SUBJECT: Dairyland Power Cooperative
La Crosse Boiling Water Reactor (LACBWR)
Possession-Only License DPR-45
Annual Decommissioning Plan Revision

The annual review of the LACBWR Decommissioning Plan has been performed, and several changes are necessary to keep the Plan current. These changes are for various reasons, such as implementation of approved Facility Changes, changes in monitoring requirements, personnel reassignments, etc. None of the changes to the Plan were determined to require prior NRC approval. The changes have been reviewed and approved by the Operations Review Committee.

FIGURE 6.1

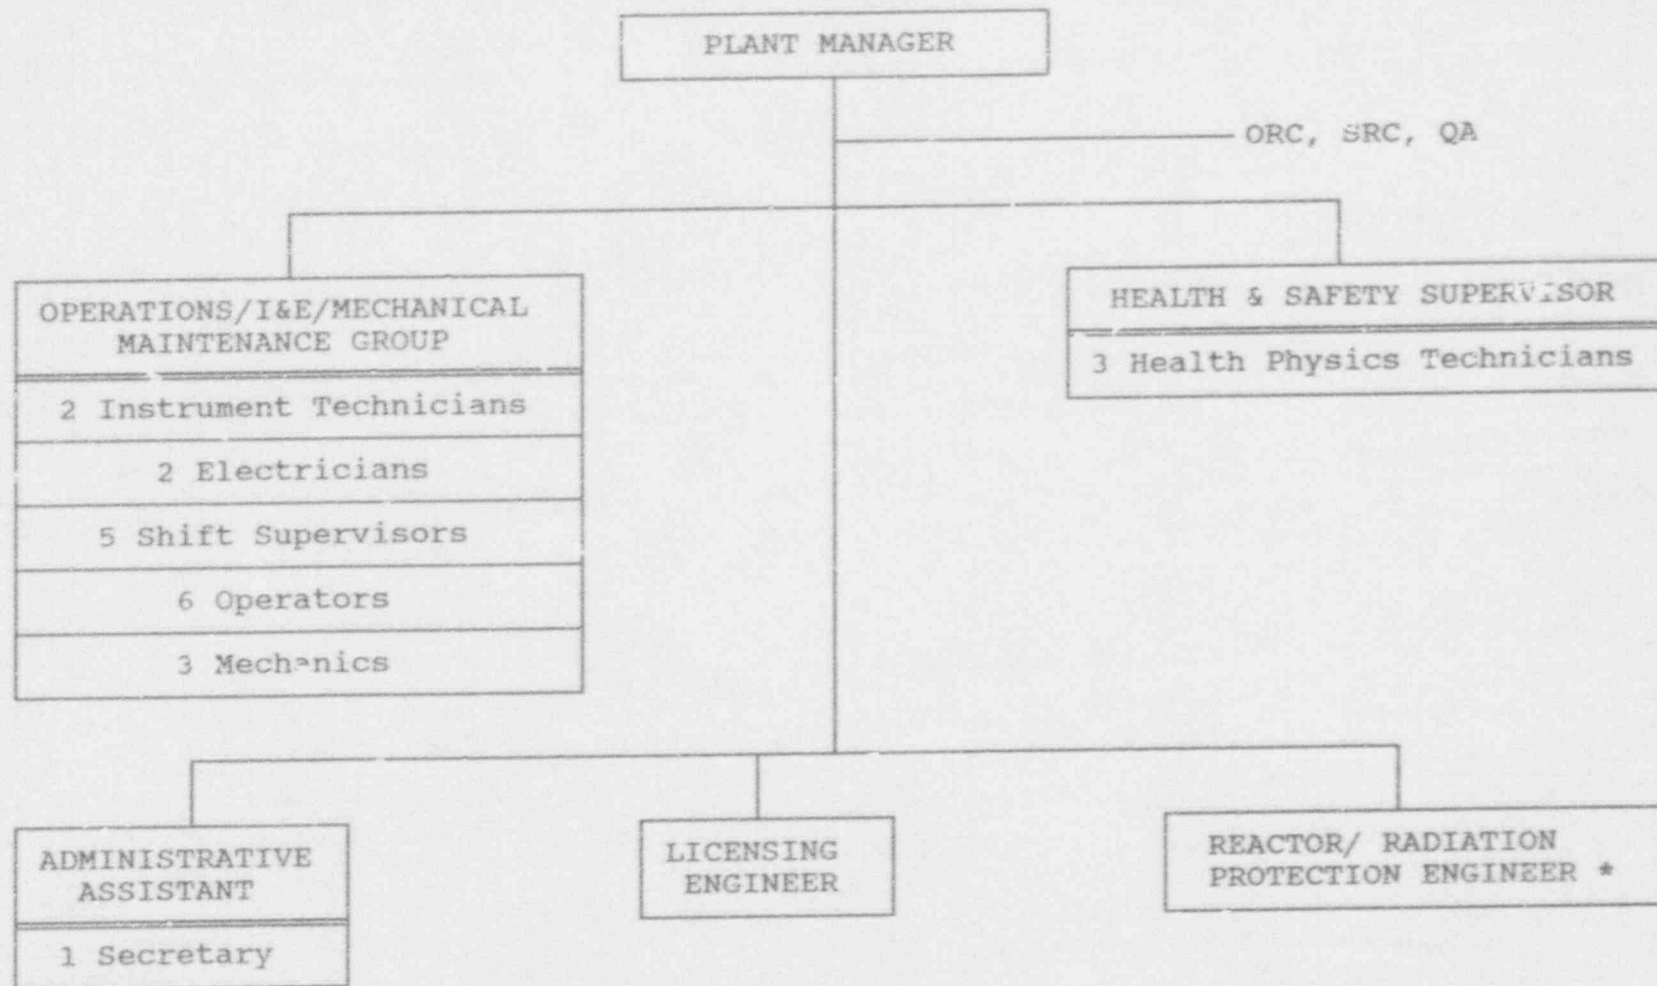
- (5) Pages 6-1, 6-2, 6-3, Figure 6-1, and page 10-1. The LACBWR Operations staff has undergone a reorganization. The Operations Supervisor position has been eliminated and the shift supervisors now report directly to the Plant Manager. The responsibilities previously assigned to this person have been assigned to several other individuals. The person last occupying this position is still in the employ of Dairyland Power Cooperative and has been assigned to the Generation Support Services group in the Cooperative office in La Crosse. This size reduction brings total LACBWR Operations staff to the level specified in the approved SAFSTOR Decommissioning Plan. Other plans that are affected by this reorganization (Security Plan, Quality Assurance Plan) will be changed and submitted following your review of the changes in this submittal.

The organization of the SAFSTOR staff at LACBWR is as indicated in Figure 6-1. The staff may change as activities being performed vary and staffing needs change. The organization is directed by a Plant Manager, who reports directly to the Dairyland Power Cooperative Assistant General Manager for Generation. The individuals who report directly to the Plant Manager each have distinct functions in insuring the safety of the facility during the SAFSTOR mode.
